Technical Note TN-902-SR

TM8100 Mobile Radio Firmware v2.02 Upgrade Instructions

22 September 2004

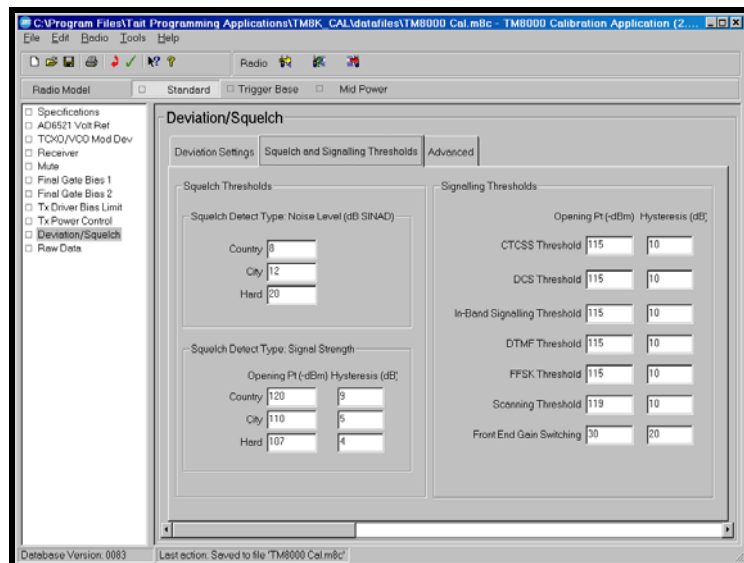
- The following pop-up dialog box will appear:

When the pop-up (above) appears during a Firmware upgrade the following procedure will apply:

- **Remove** the DC supply to the radio
- Wait 5 seconds
- Re-apply the DC supply
- Power-up the radio with the control head on/off button (if it has not already powered-up)
- The pop-up box will then disappear and the upgrade process continues.
